**DEPARTMENT OF TRANSPORTATION
STATE OF GEORGIA**

FILE: STP00-0002-00(409) Dougherty **OFFICE:** Engineering Services
 NH000-0006-02(056)
 P.I. Nos.: 0002409 & 422560
 SR 520/Clark Ave. and Ramp Improvements **DATE:** February 17, 2011

SUBJECT: IMPLEMENTATION OF VALUE ENGINEERING STUDY ALTERNATIVES

SUBJECT Value Engineering Study Report Responses

Converting Permanent Easement to Required Right of Way

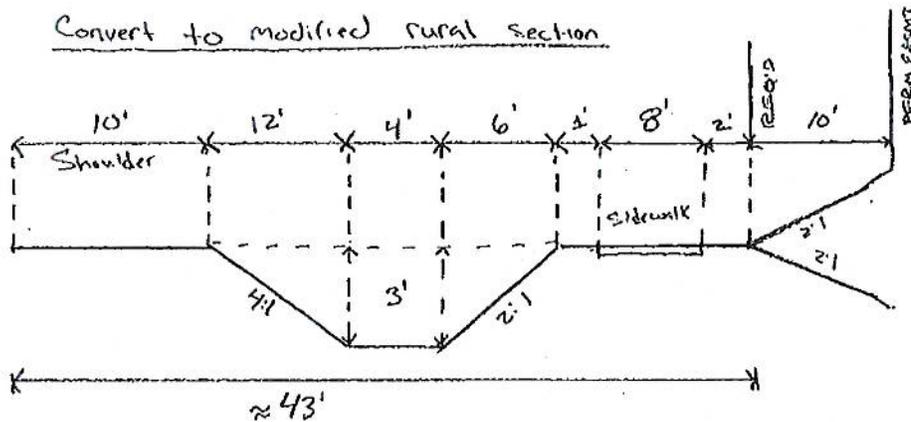
D-4: Use modified rural section in select area

No, will not implement. The VE recommendation in the report assumed that the permanent easement would be converted to required right of way and that the cost for each is the same. The permanent easement cost estimate submitted to the VE team used a price per square foot cost that is half of the price per square foot of required right of way. The additional cost to convert permanent easement to required right of way is \$35,903.05. The VE report recommendation did not provide dimensions for the modified rural section. This office assumes the modified rural section will meet clear zone distance requirements. This office developed a typical section for the modified rural section (see attachment). The modified rural section will require 43 feet of right of way from the edge of pavement and additional 10-foot of easement to tie in the slopes. Using this typical section will require additional required right of way and easement at a cost of \$69,400.07. It will also require the relocation of a minimum of 6 mobile homes at a cost of \$240,000. The additional cost for right of way and relocation of trailers will be \$309,400.07. This cost is higher than the proposed savings in the VE Report recommendation.

$$\begin{aligned} \hookrightarrow \text{Cost of Perm EASMT} &= (31,913.8239) (\$2.25/\text{sf}) (50\%) \\ &\Rightarrow \$35,903.05 \end{aligned}$$

$$\begin{aligned} \hookrightarrow \text{Cost to Convert to REQ'D} &\Rightarrow (31,913.8239) (\$2.25/\text{sf}) \\ &\Rightarrow \$71,806.10 \end{aligned}$$

$$\hookrightarrow \text{Cost of additional REQ'D} \approx (7838.82 \text{ SF}) (\$2.25/\text{sf}) \Rightarrow \underline{\$17,637.35}$$

$$\hookrightarrow \text{Cost of additional PERM EASMT} \approx (14097.488 \text{ SF}) (\$2.25/\text{sf}) (50\%) \Rightarrow \underline{\$15,859.67}$$

$$\hookrightarrow \text{Total cost of R/W} \Rightarrow \$35,903.05 + 17,637.35 + 15,859.67 \Rightarrow \underline{\$69,400.07}$$

$$\text{Total Cost} = \$69,400.07 + \$240,000.00 = \underline{\$309,400.07}$$
